COMMENTS ON STATEMENT REF: EX15

SCARBOROUGH BOROUGH COUNCIL'S RESPONSE TO THE INSPECTOR'S REQUEST CHURCH CLIFF DRIVE, FILEY – SITE HA 23 (FLOODING INFORMATION)

Submitted by: Robert Agus

EXTRACT 1: TAKEN FROM FIGURE 11.11 OF THE SFRA

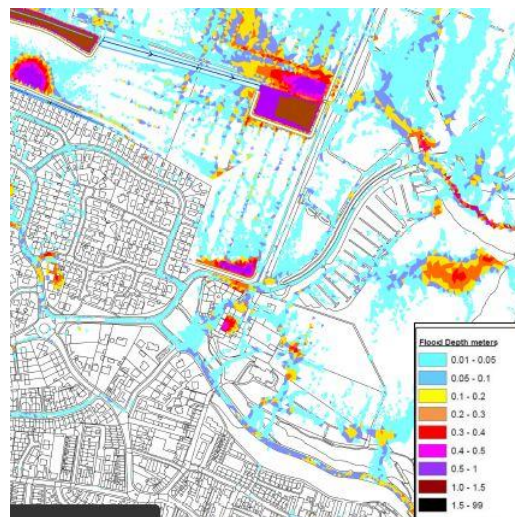
Furthermore, SBC's response to the Inspector's request, comments only on the Strategic Flood Risk Assessment (SFRA) Figure 11.11 (this is dated January, 2010). This shows a hatched area indicating "*Proposed Flood Storage Areas*" which were to be developed as part of the Filey Flood Alleviation Scheme (Filey FAS). Extract 1 below shows these areas with purple hatching.

Usefully, this shows that Site HA23 would be protected from flood risks. Furthermore, the SFRA fails to note that the blue hatched areas showing the extent of flooding are principally related to reported incidences of flooding, and it is not difficult to conclude that although surrounding fields may have flooded, no one would have reported these incidences.

However, it is disrespectful to both The Inspector and to the local residents that SBC do not acknowledge that Figure 11.11 is now incorrect and out of date, again resulting in a significantly unsound assessment of the classification of Site HA23 with regards to flood risks.

Indeed, Figure 11.11 is now entirely incorrect in relation to the layout of the proposed bunding, and the associated proposed flood storage areas. Extract 2 below shows the areas of historical flooding and flood storage areas associated with the Filey FAS.
